**RE: SUPPLEMENTAL INFORMATION REQUESTS - ALBERTA SULPHUR
TERMINALS SULPHUR FORMING AND SHIPPING FACILITY**

This letter provides responses to the Supplemental Information Requests (SIR's) included in your letter of January 4th, 2008. For ease of reference, each question is reiterated in italics prior to providing the supplemental information.

Figure 32-1: Isopach map

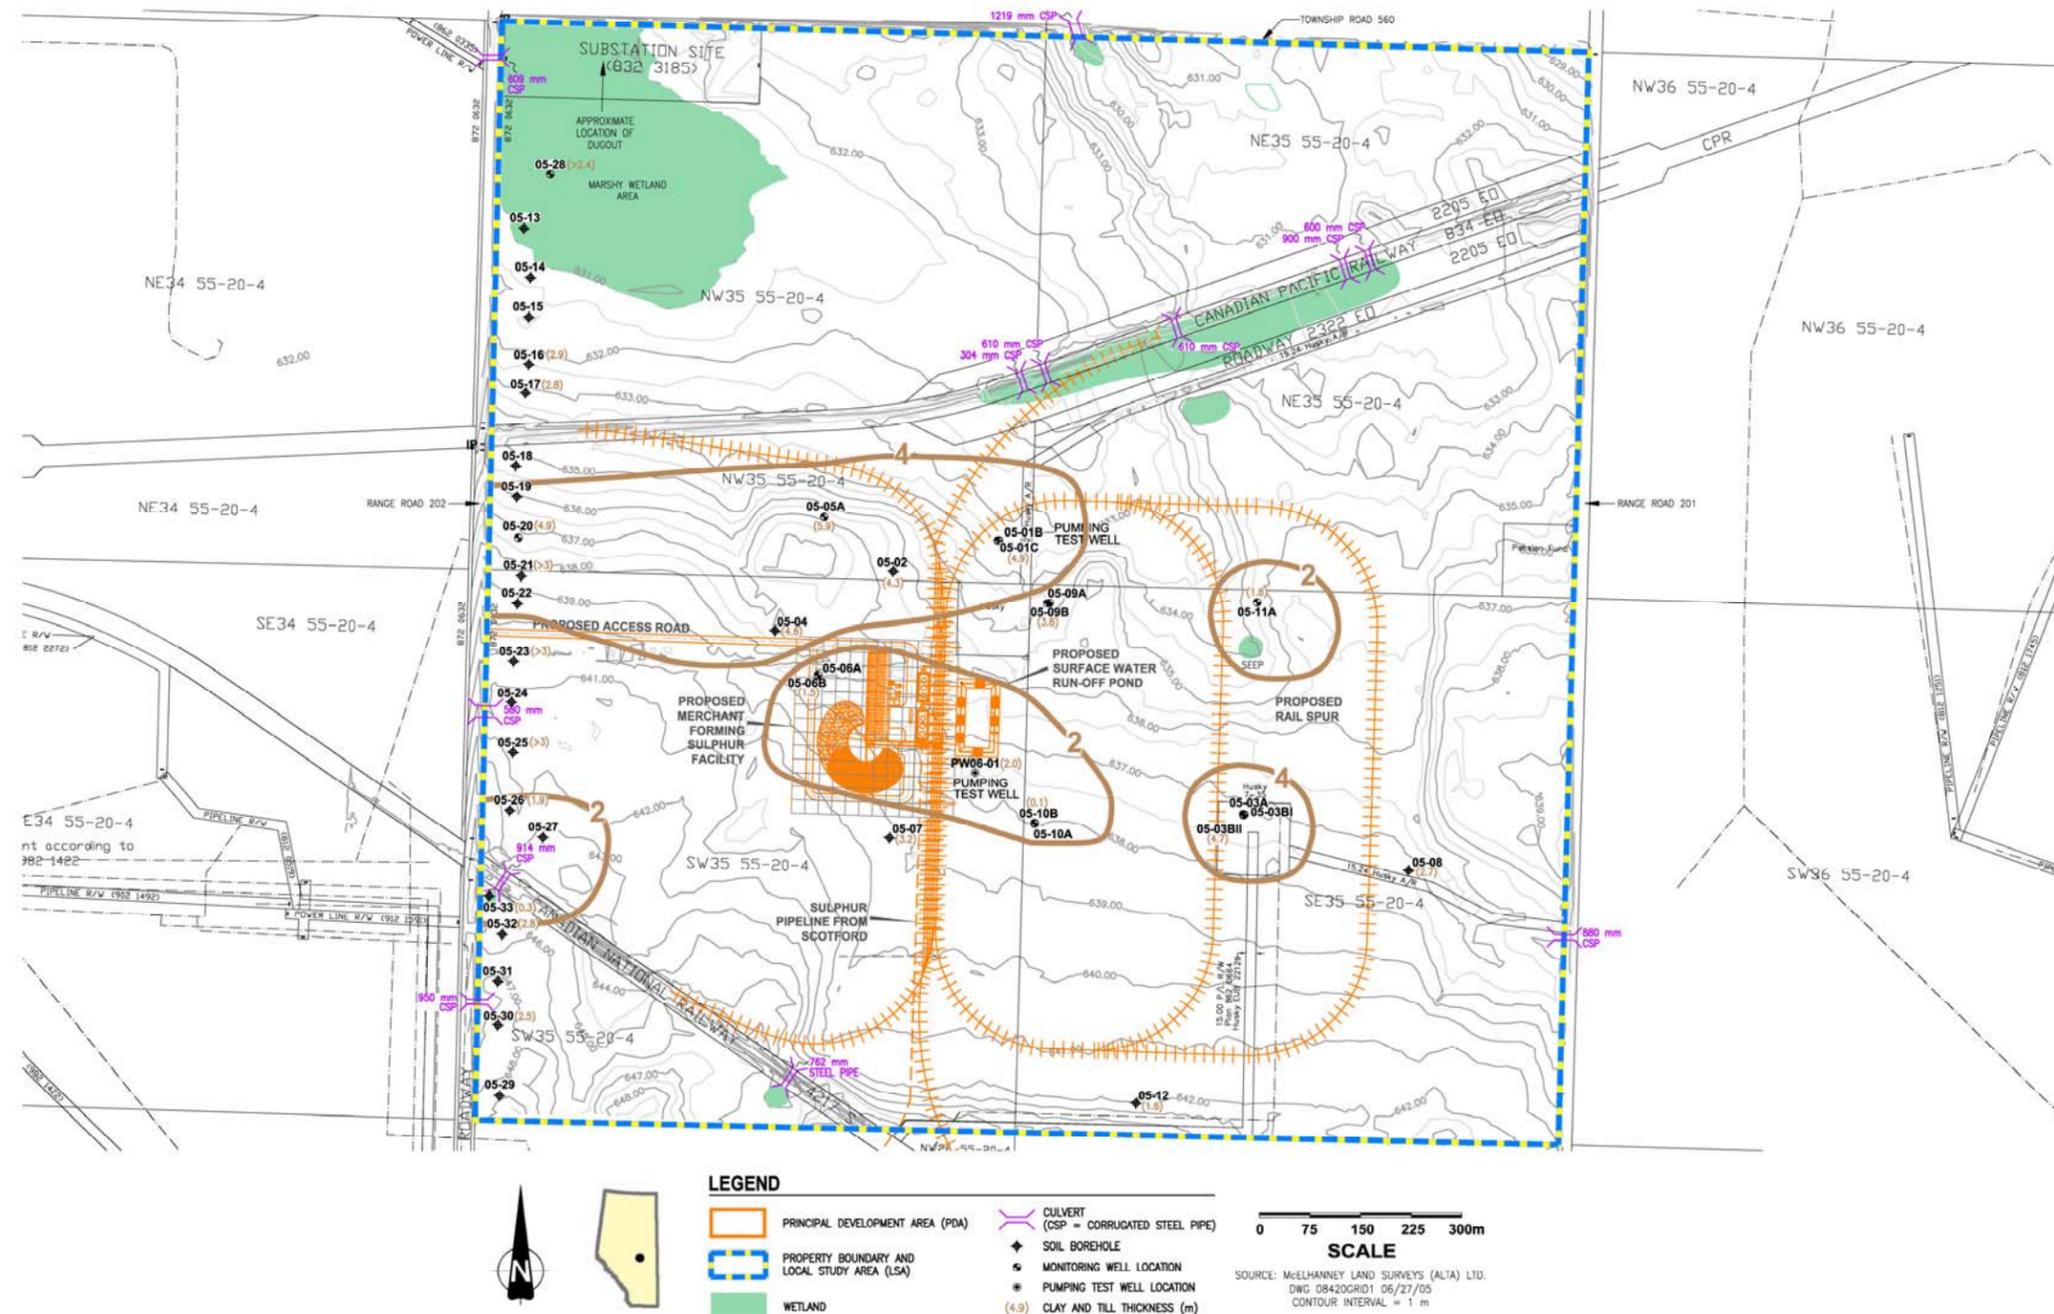
- a) *Provide an isopach map for this surficial deposit. Identify areas where it may be absent and not able to adequately protect the upper bedrock aquifer from potential contamination.*
- A. An isopach map for clay and till deposits has been provided as Figure 32-1. The clay and till is thickest (greater than 4 m) to the north and northwest of the proposed facility location. The thickness of clay and till deposits appears to gradually decline northward towards the wetland area. However, at the wetland these deposits are still a minimum of 2.4 m thick (MW05-28). The clay and till deposits vary in thickness from 1.5 m (MW05-06A/B) to 2.0 m (PW06-01) underneath the proposed facility. Clay and till may be absent immediately to the east of the plant site (MW05-10A/B) and locally along the Site west perimeter (BH05-33).

Figure 33-1: Horizontal extent of silty sand

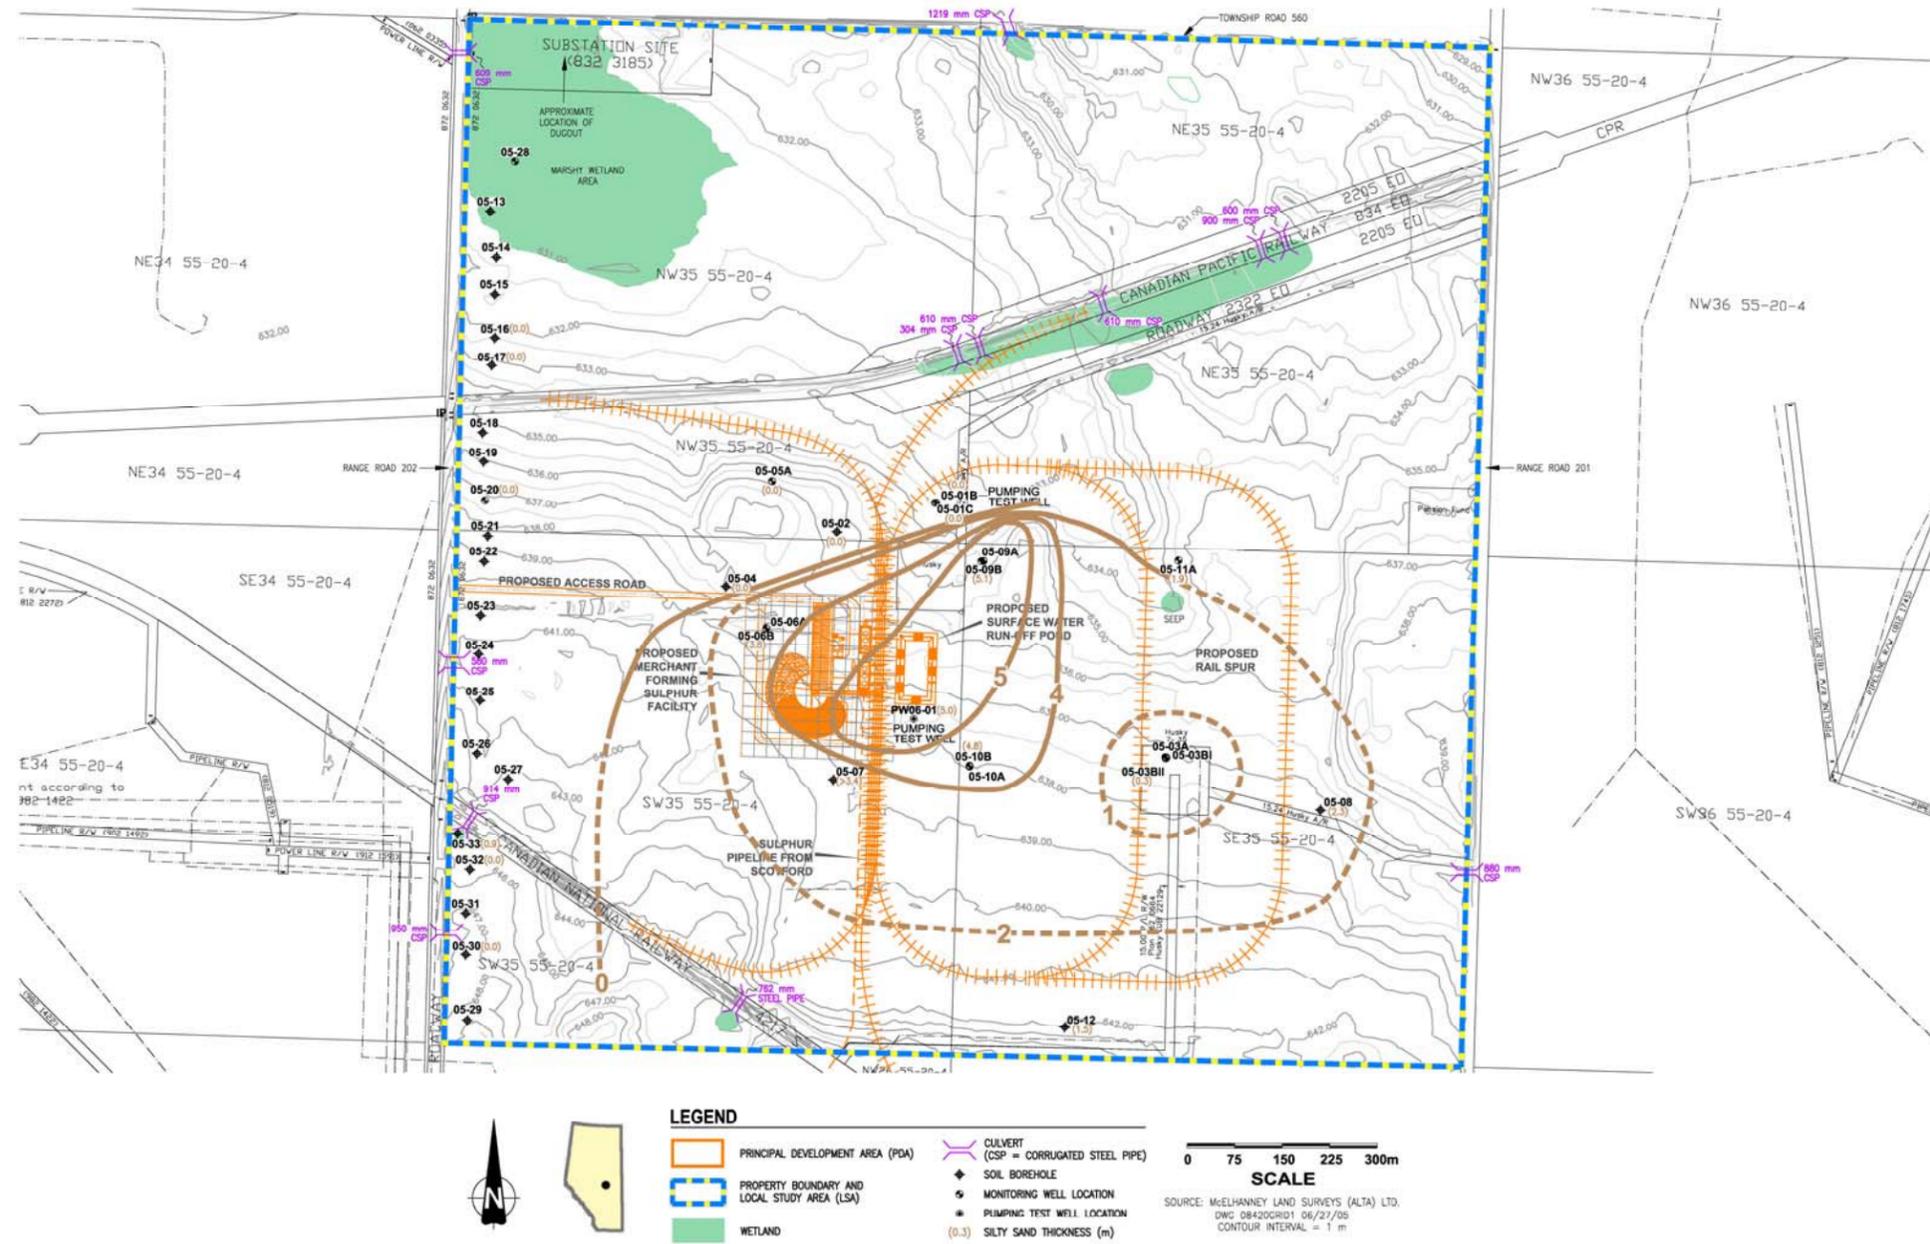
- c) *Describe the movement of contaminants through this unit and identify potential receptors.*
 - d) *Confirm that the sand deposit does not extend north of the Project and is not hydraulically connected to domestic water wells located hydraulically downgradient of the Project site. Provide a hydrogeological cross-section to support AST’s response.*

- A. A map showing the horizontal extent of the silty sand is provided as Figure 33-1. The vertical extent of the silty sand is illustrated on the cross-sections submitted in Volume IIB as Figures 2.5.3 to 2.5.5. The main hydraulic conductivity and groundwater velocity characteristics of the silty sand were summarized in Volume IIB, Section 2.5.4.2 and Table 2.5-1 and are reproduced below.

- C. Figure 33-1 and the cross-sections submitted in Volume IIB as Figures 2.5-3 and 2.5-4 indicate that the silty sand is discontinuous and pinches out to the north and west of the proposed facility location. Any lateral movement of contaminants within the silty sand would therefore be limited to the PDA. The silty sand is not connected to any potential receptors.
- D. Figure 33-1 and cross-sections 2.5-3 and 2.5-4 indicate that the silty sand is discontinuous and pinches out to the north and west of the proposed facility location. Significant thicknesses of silty sand are only encountered at the PDA. Therefore, the silty sand is not hydraulically connected to domestic water wells located downgradient of the Project site.

Figure 66-1: Isopleths of Maximum Predicted Hourly Average Ground-level H₂S Concentrations (µg/m³) Associated with Area Source Emissions Resulting from Project Operations

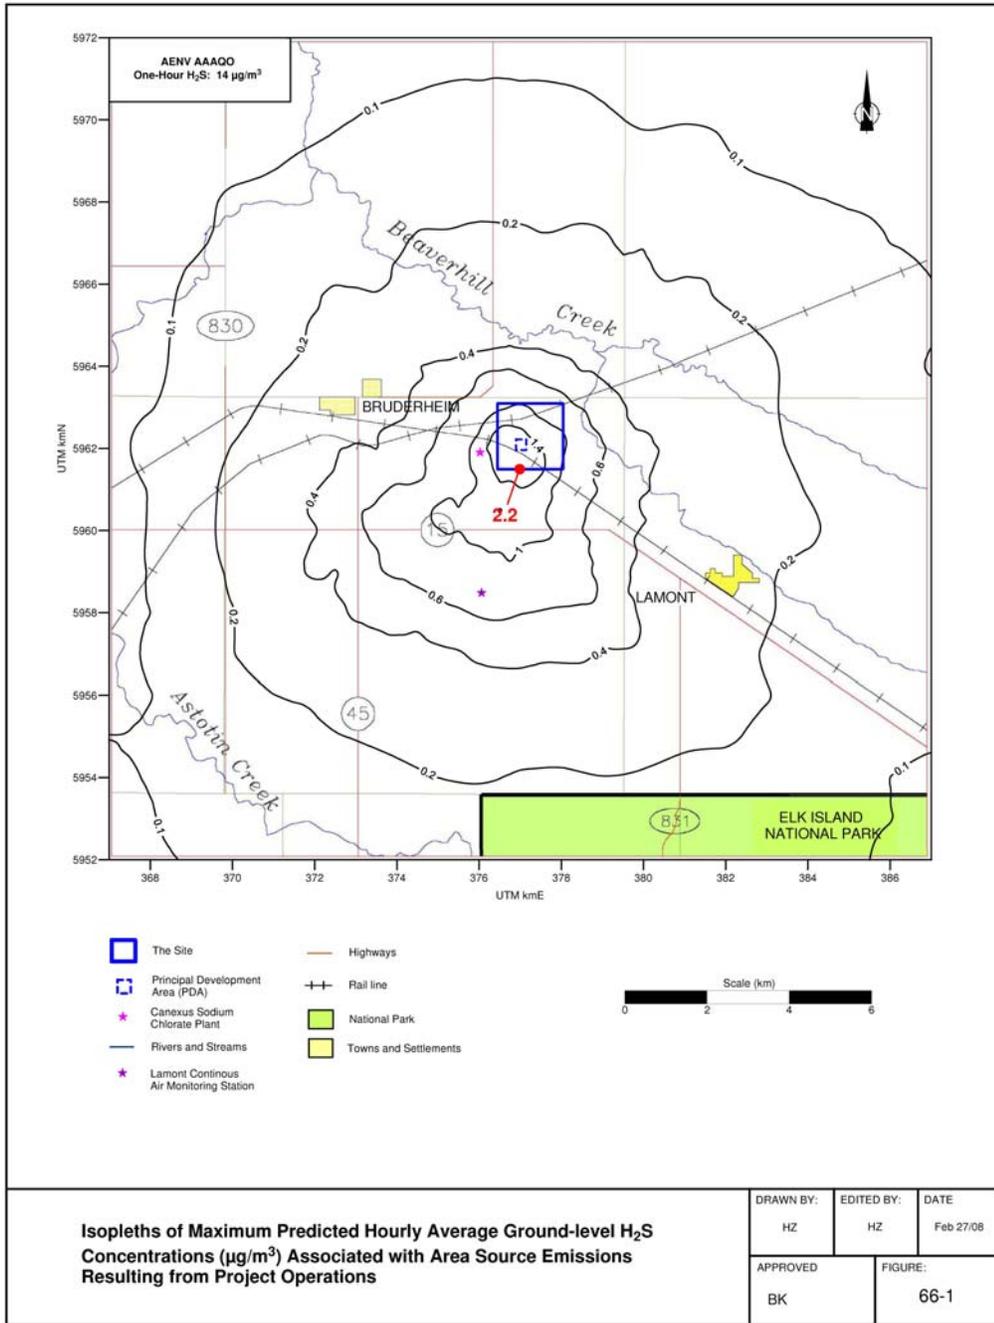
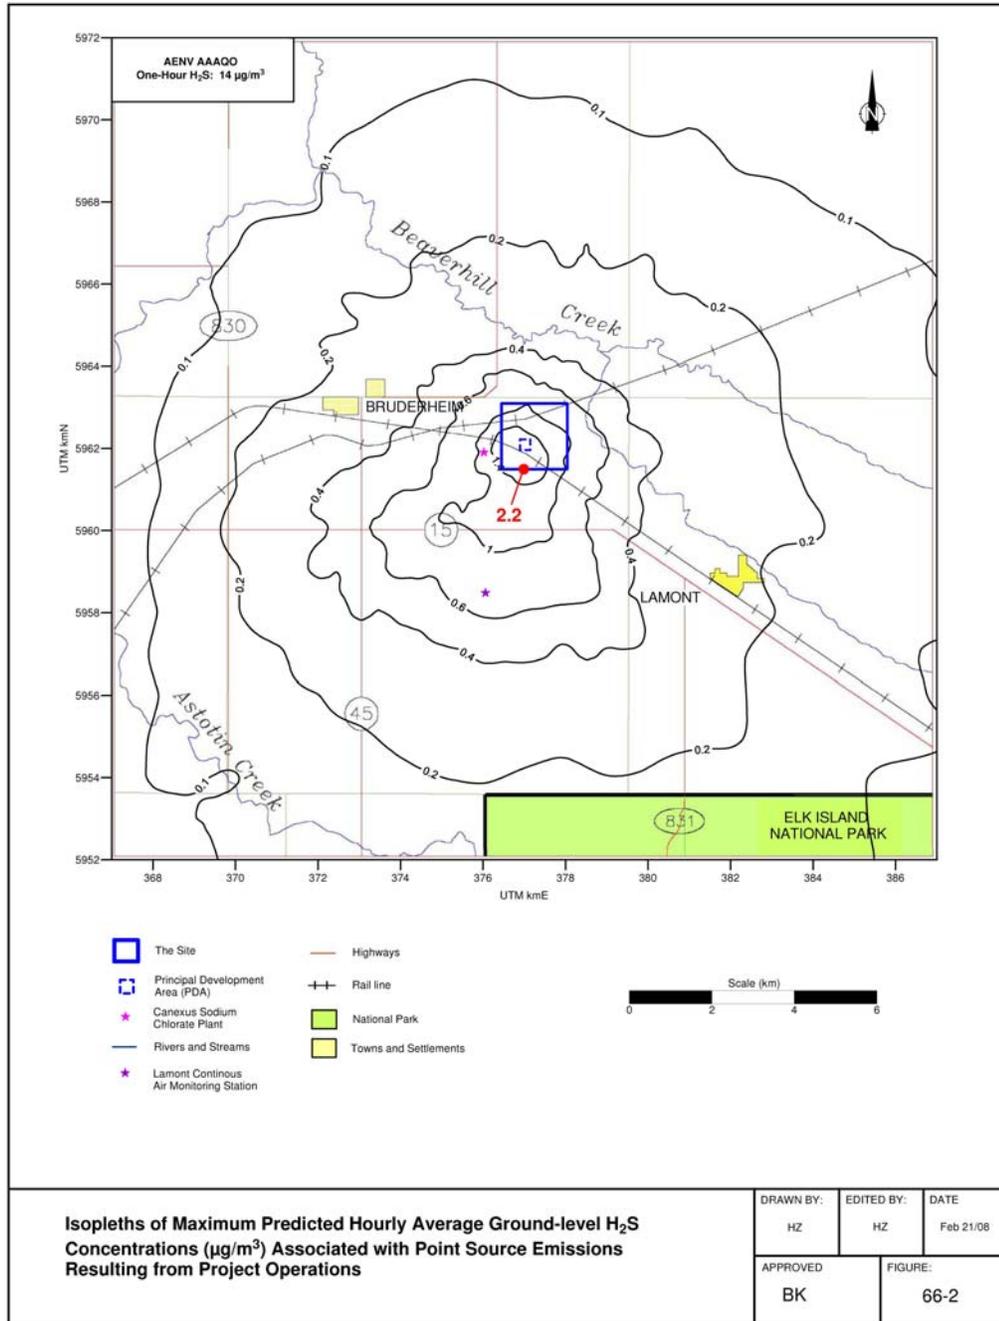
- b) *As shown on Figure 2.5-1 there are three SulfaTreat vents associated with the storages tanks. Explain why emissions from storage tanks are considered to be area sources instead of point sources. Provide a detailed calculation of how H₂S emissions were calculated from the storage tanks and how those emissions were apportioned to an area source.*

- C. Figures 66-1 and 66-2 present dispersion modelling results for maximum hourly average ground-level concentrations based upon the assumption that the tank vents behave respectively as area and point sources. The results are, as expected, virtually identical. This is because the area source dimensions are small compared to the size of the plume as it spreads at downwind distances to the Plant boundary. Additional calculations for daily averages showed that results for assumed area and point sources were also virtually indistinguishable.

Figure 2.5-14: Isopleths of Maximum Predicted Annual Average Sulphur Deposition Values (kg/ha/y) associated with Project Emissions

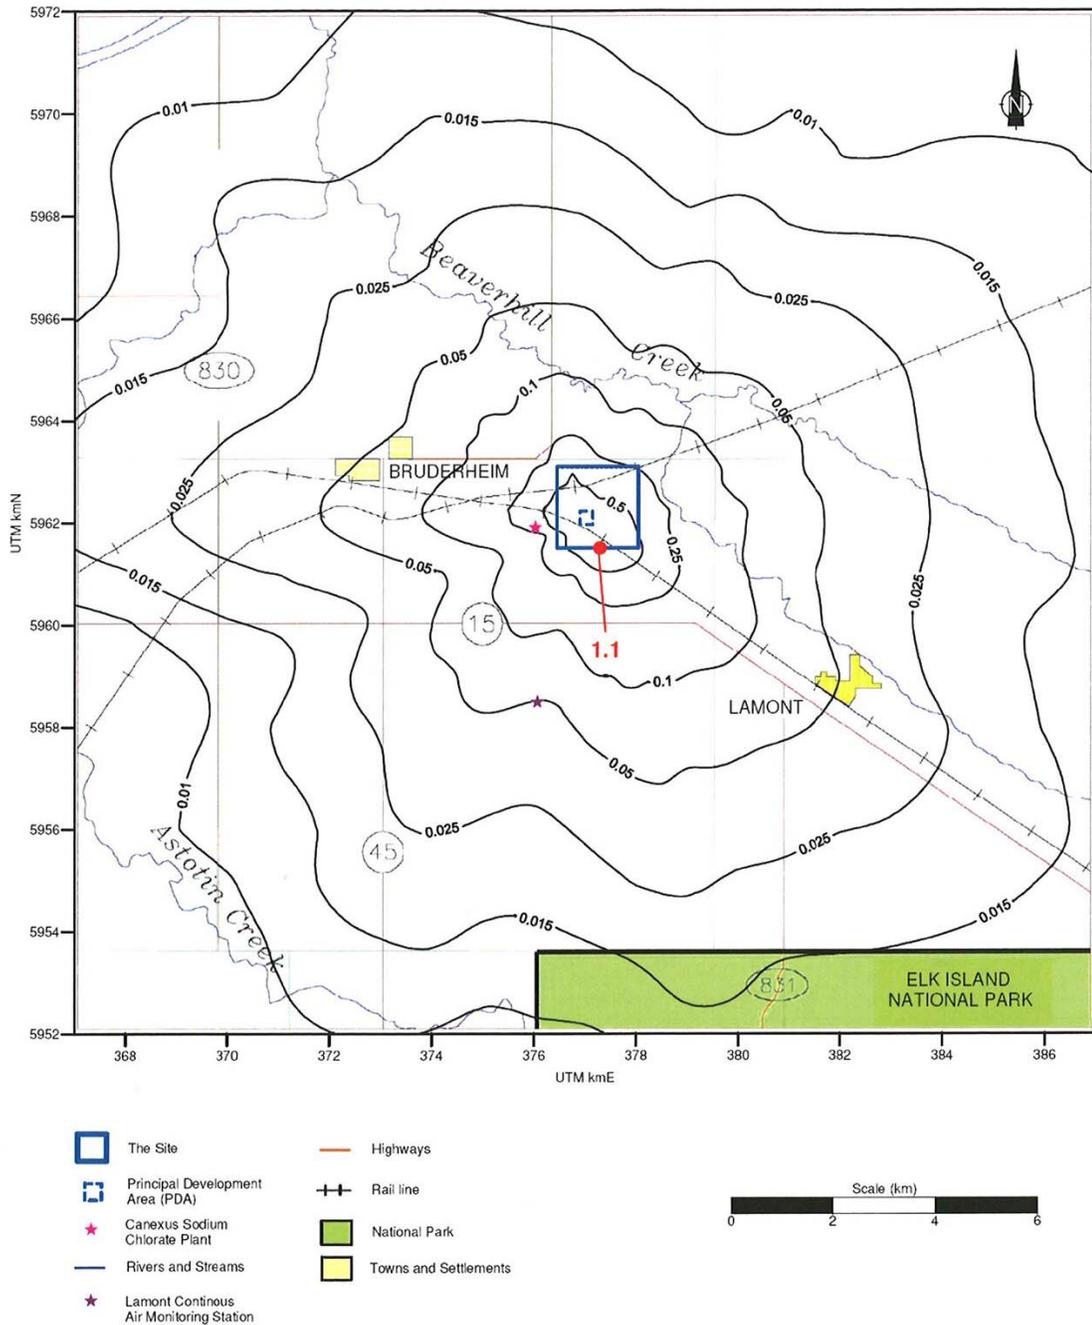
10. **Volume IIA, Sections 2.0 and 2.5.3, Figure 2.5-14, Page 2-60; Volumes IIC, Section 2.6.10, Page 2-46.** *Based on the sulphur deposition modelling data, AST predicts that the maximum average predicted annual deposition of sulphur at the Site boundary would be 1.11 kg/ha/yr.*

- A. The modelling results shown in Figure 2.5-14 were used to determine the mixing proportions of the sodium chlorate and sulphur in the 99.998% sodium chlorate and 0.002% sulphur test. The proportion of sodium chlorate in the sample was determined using data provided by Canexus.

The rotoform stacks and facility loading area will be sources of particulate emissions of sulphur. Figure 2.5-14 presents maximum predicted annual average sulphur deposition values (kg/ha/y) associated with Project emissions. They were estimated through use of the CALPUFF model (see Volume IIA, Section 2, Appendix I). The highest value of 1.1 kg/ha/y is predicted to occur along the south Site boundary.
